TO: Steve Wilde
FROM: Ben Everitt
SUBJECT: Report on Spillway Excavation at
Smith and Morehouse Dam

UGMS HAZARDS SECTION

Figure 1

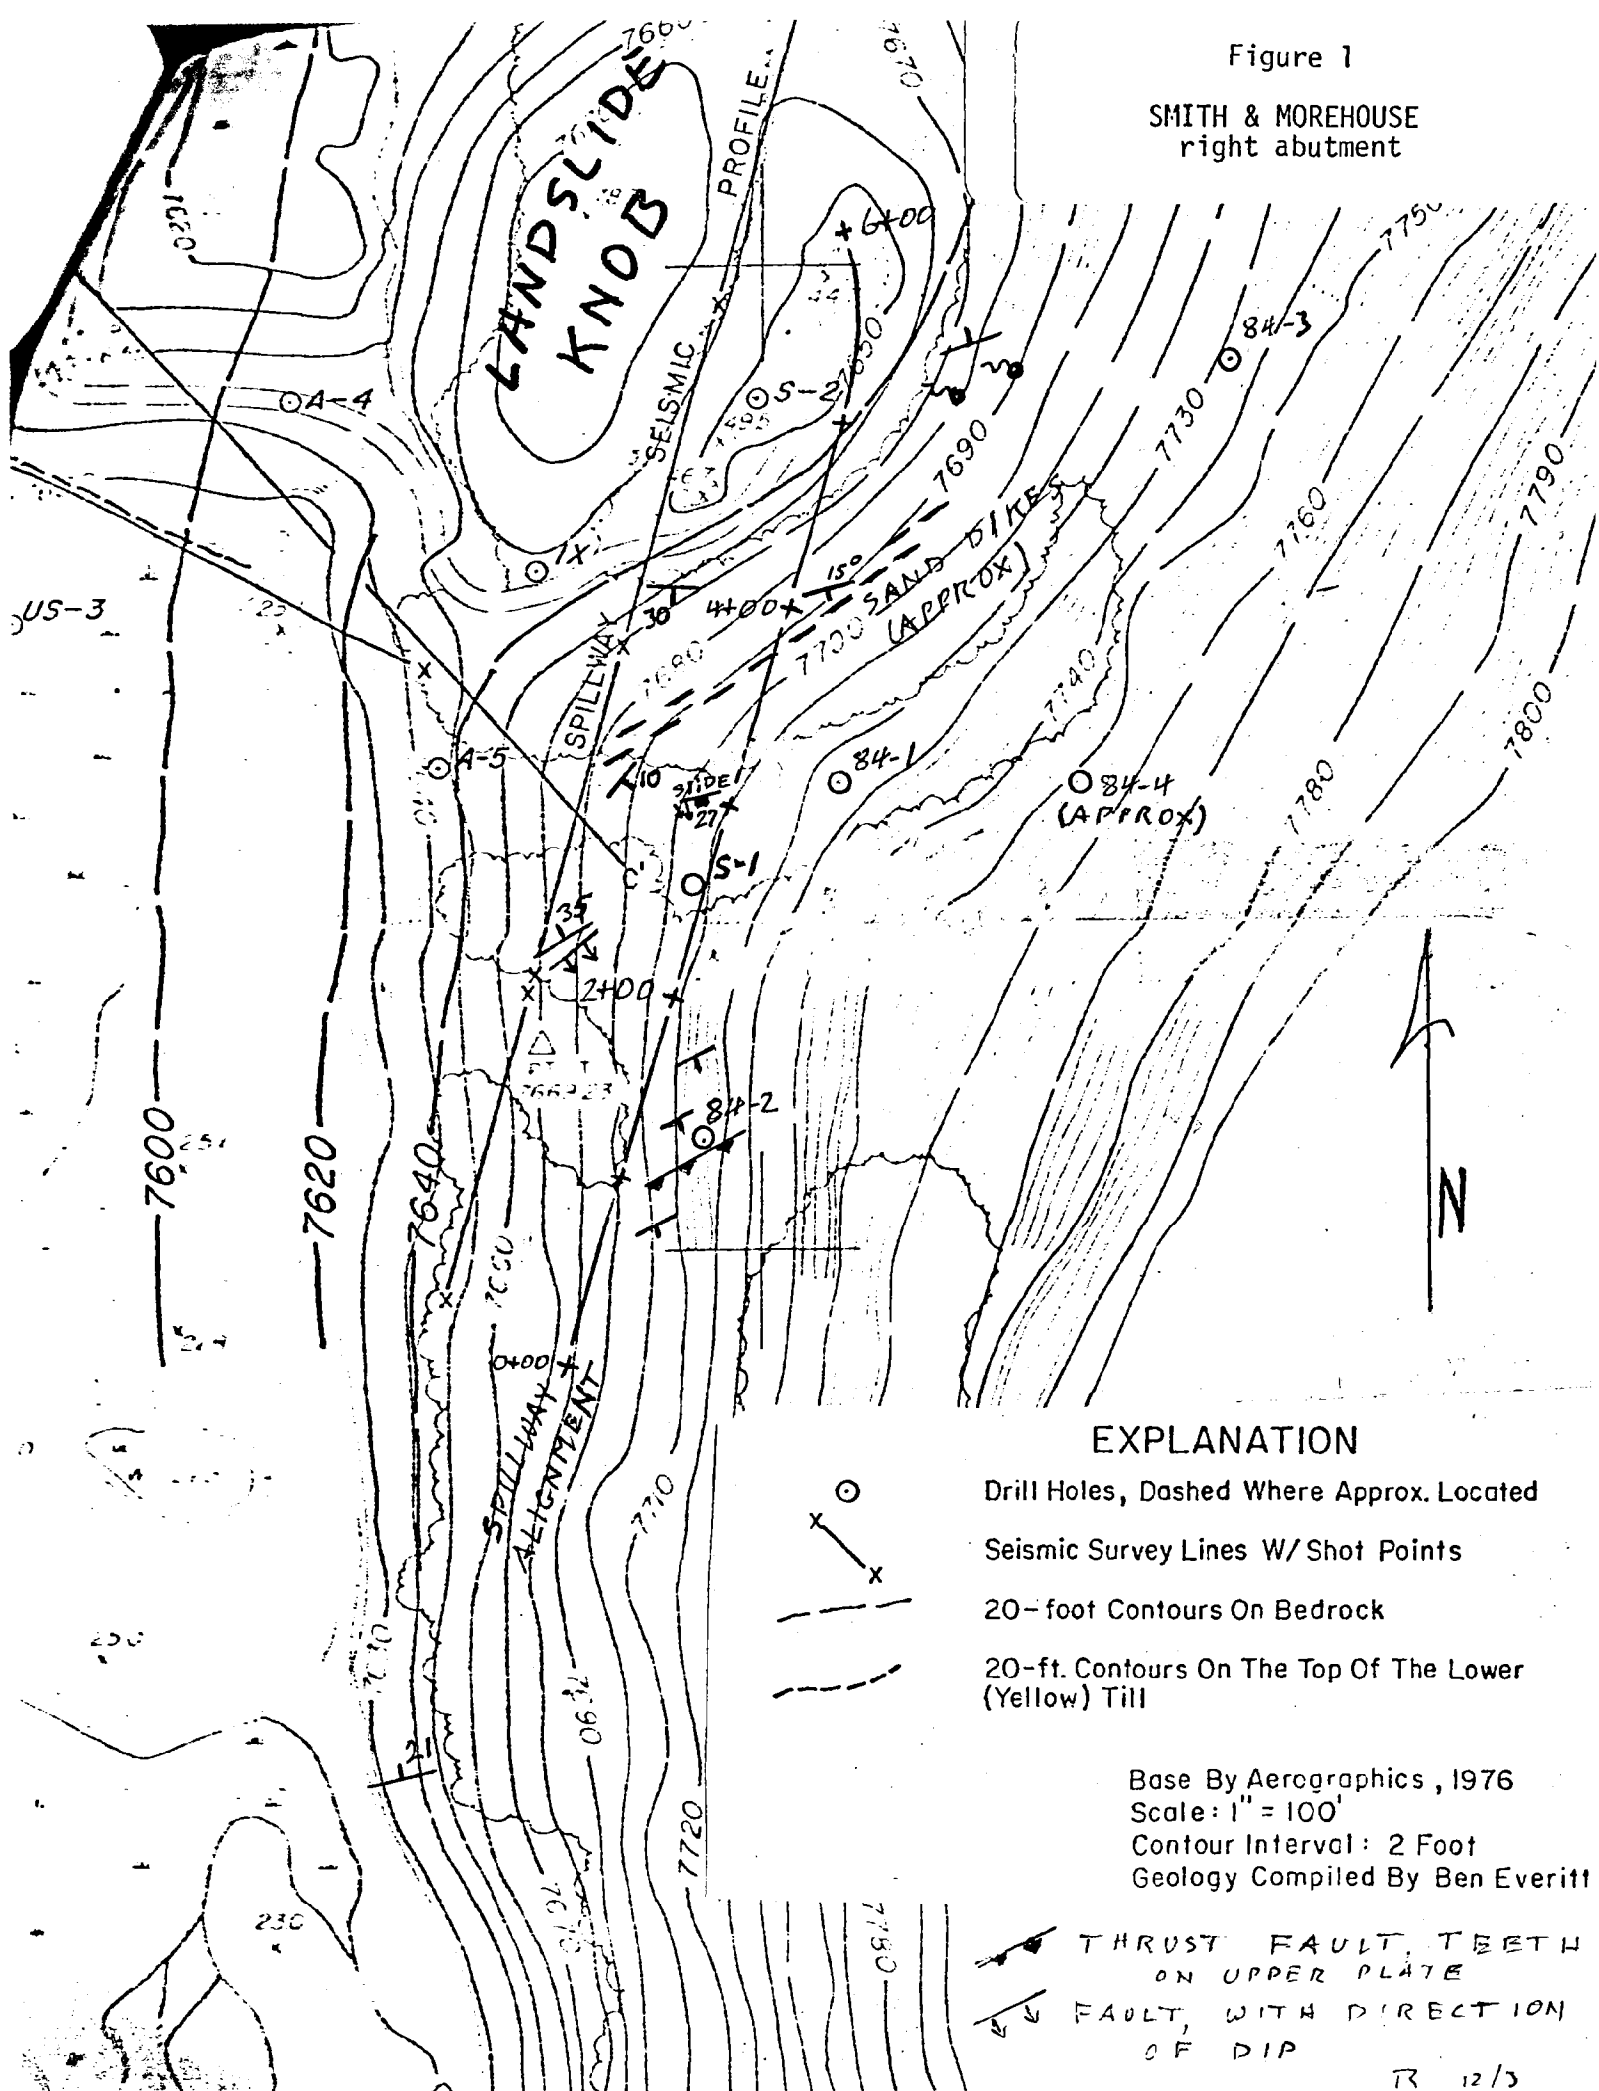
Drill hole 84-3 of the current series (Figure 1) spudded in hard limestone and recovered nearly 100% of core for 90 feet. The interval from 91-94 feet recovered 8 inches of black organic muck containing some spongy peat, confirming the existence of a massive deep landslide in the right abutment and spillway area.

As a result of these recent discoveries, there are three aspects of the safety of the dam which should receive careful consideration.

Landslide. - - The stability of the right abutment and spillway. Can we be reasonably sure that it will remain in place during and after construction?

Sand Seams. - - Do the sand seams provide avenues of pipeable material beneath the dam? This question has a bearing on stability and seepage through the abutment. Only a thorough examination of the key trench will answer this question, but it wouldn't hurt to be prepared with some contingency plans if sand seams are found to extend beneath the key trench.

Seepage. - - Although we have already recognized the need to control seepage around the right abutment, this need becomes more important now that we recognize that stability of the abutment is an issue.
